Technical Service Bulletin

SUBJECT:		No: TSB-20-15-001REV	
RATTLE NOISE FROM HEAT PROTECTOR OF EXHAUST MANIFOLD		DATE: October 2020	
		MODEL: See Below	
CIRCULATE TO:	<input type="checkbox"/> GENERAL MANAGER	<input checked="" type="checkbox"/> PARTS MANAGER	<input checked="" type="checkbox"/> TECHNICIAN
<input checked="" type="checkbox"/> SERVICE ADVISOR	<input checked="" type="checkbox"/> SERVICE MANAGER	<input checked="" type="checkbox"/> WARRANTY PROCESSOR	<input type="checkbox"/> SALES MANAGER

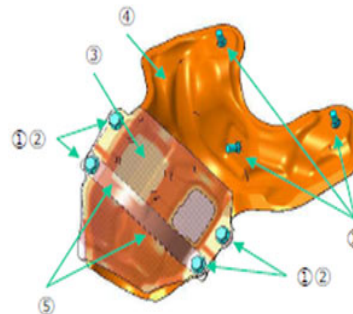
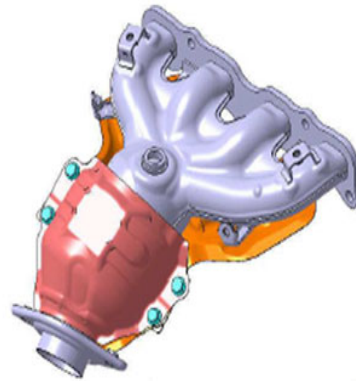
1. Remove the #1 bolts and #2 nuts from the Exhaust Manifold.
2. Remove the #3 and #4 Heat Protector.
3. Remove the #5 Fixing Band.
4. Install the new Heat Protector Assembly to the Exhaust Manifold in reverse of the removal order:
3 -> 2 -> 1.

Tightening torque for No.1 bolts and No.2 nuts : 12-25N·m
